SUNRAY SHORES WATER DISTRICT SUNRAY SHORES C#1 PUMP STATION, STORAGE AND TRANSMISSION MAIN BELMONT, NEW HAMPSHIRE

ADDENDUM #1

DATE: JULY 29, 2024 TO: PLAN HOLDERS

SHEET 2.01

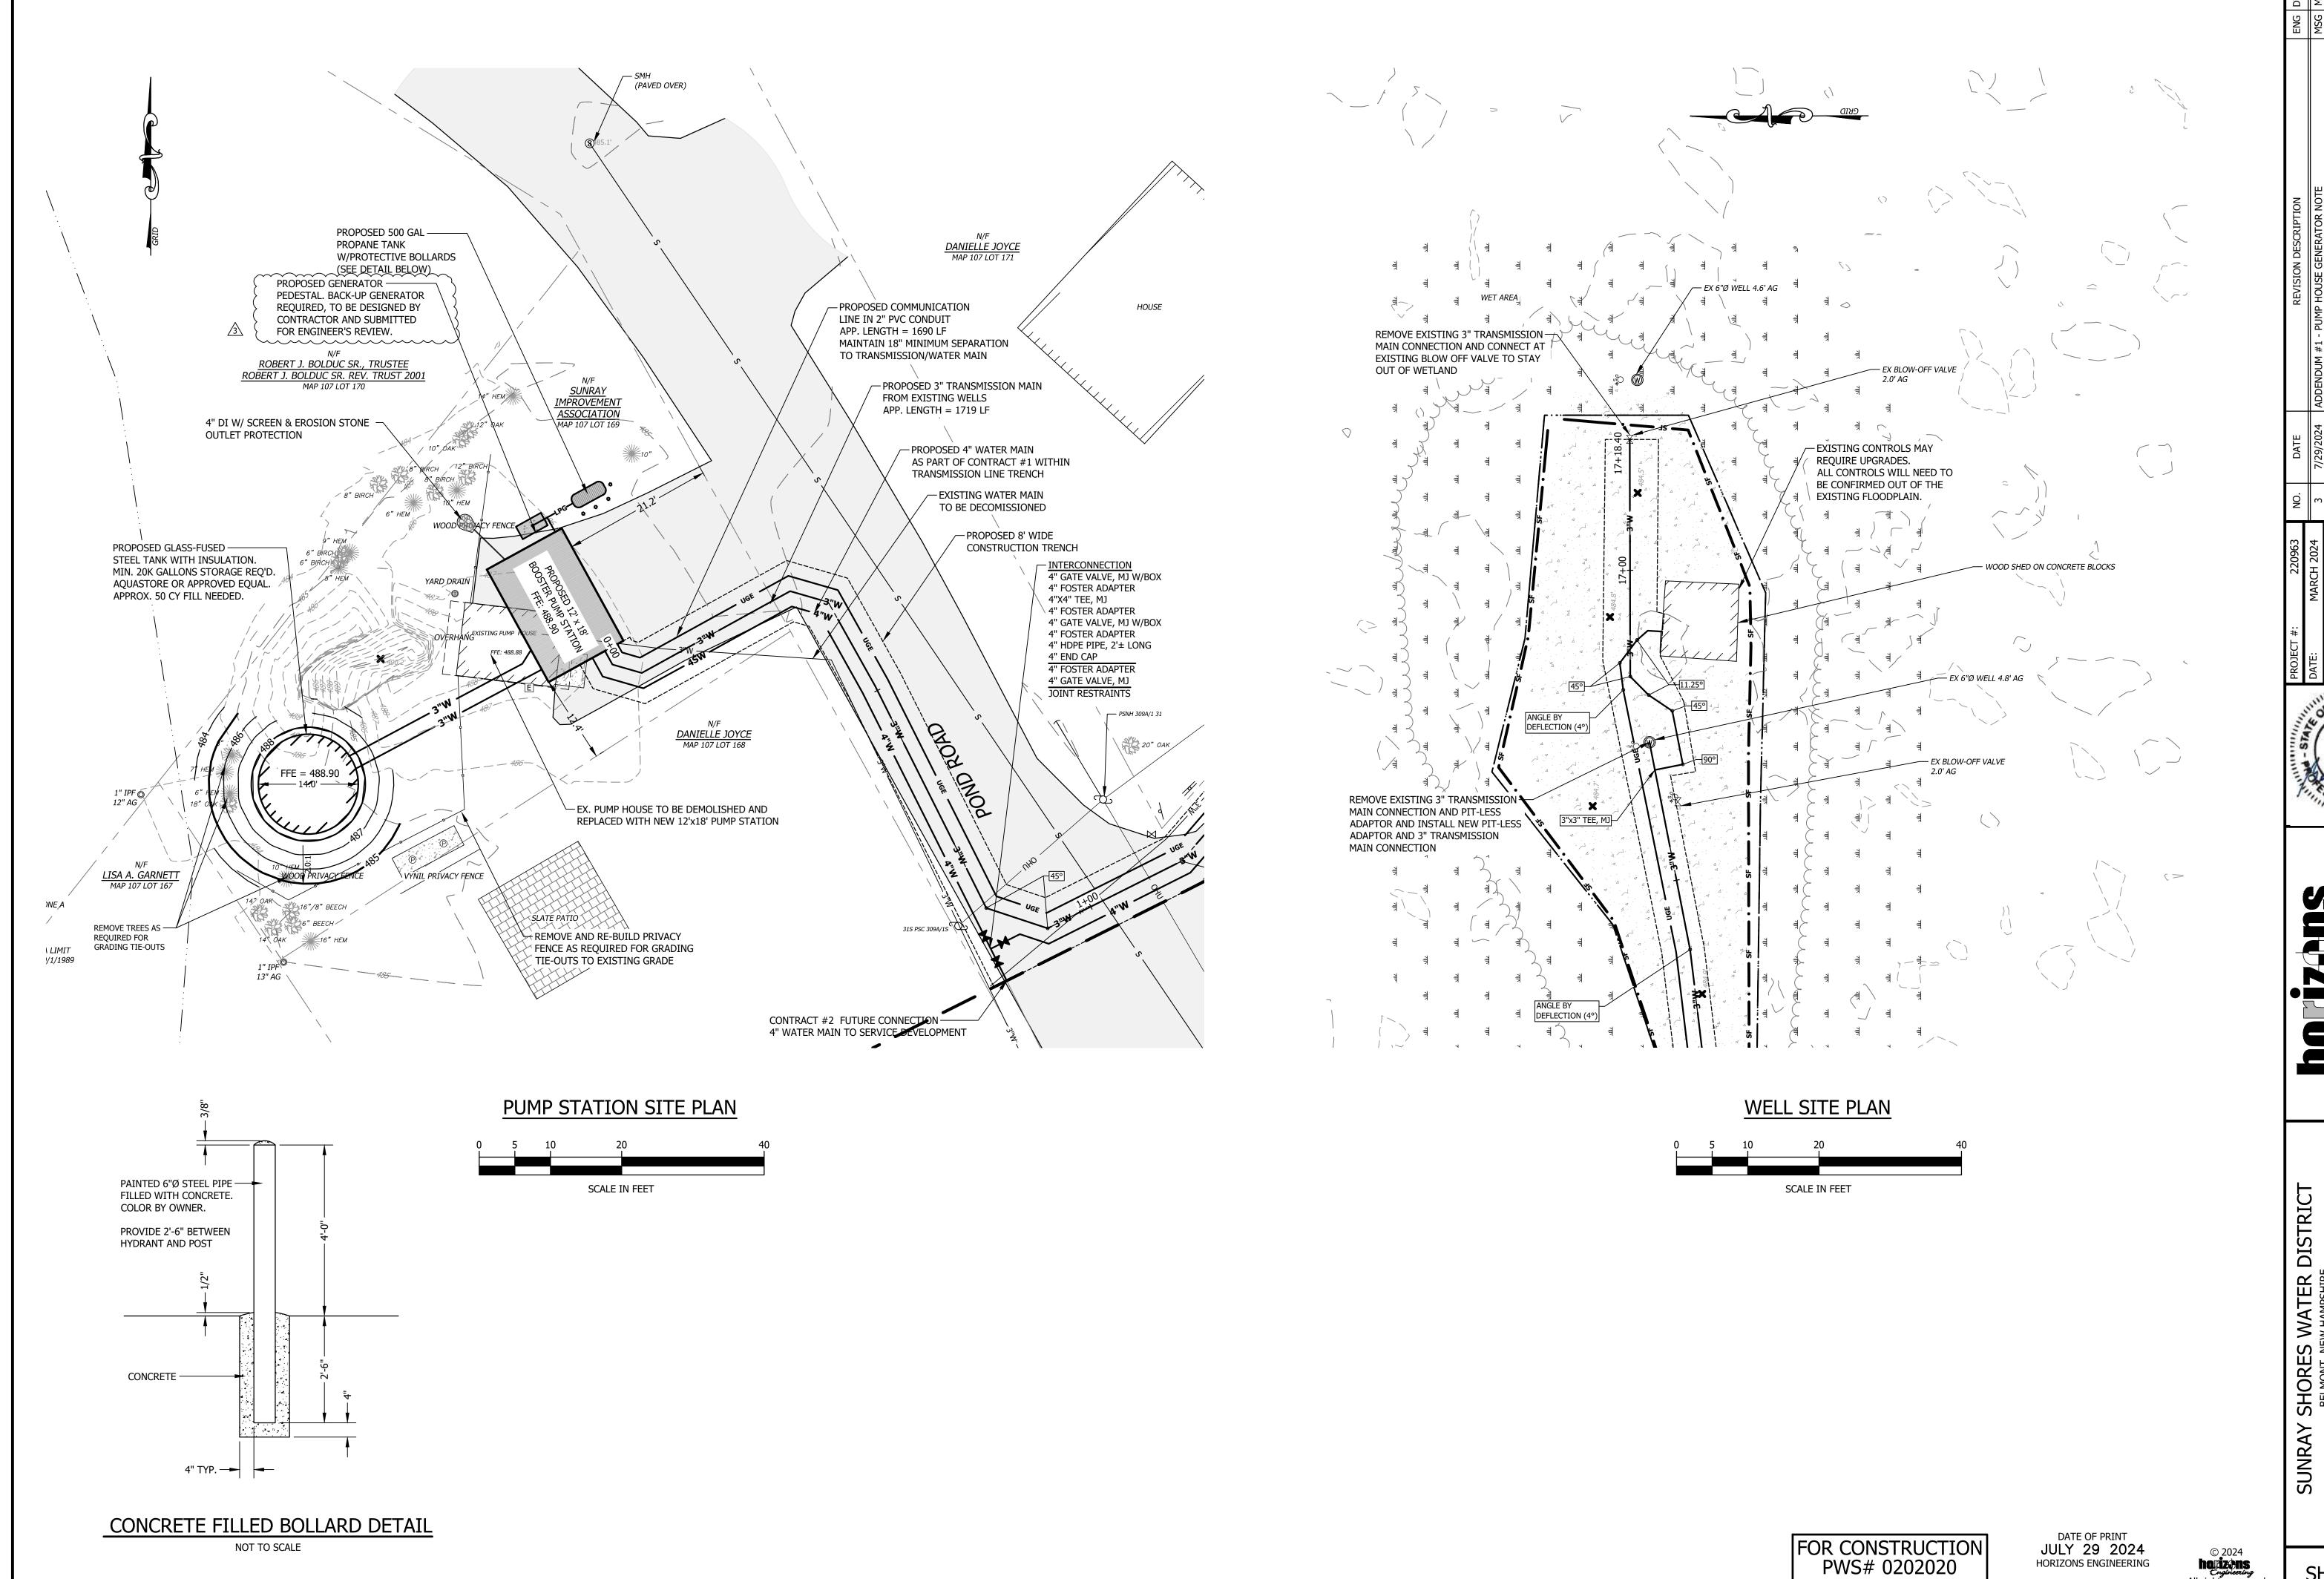
1. Sunray Shores Water District Contract #1 Civil Plan Set. Sheet 2.01 has been revised to expand on the note for the requirement of a back-up generator. Conceptual location of pedestal and propane tank are shown in the same location as previously shown. Revised call-out has been clouded and noted on the plans with a Revision 3 triangle for clarity.

- b. As noted in Item 1 of this addendum, a back-up generator will be required for this project. Shop drawings for the generator will need to be submitted to the Engineer for review and approval. Sheet 2.01 has provided a conceptual location for a generator pedestal and 500-gallon propane tank near the proposed pump house.
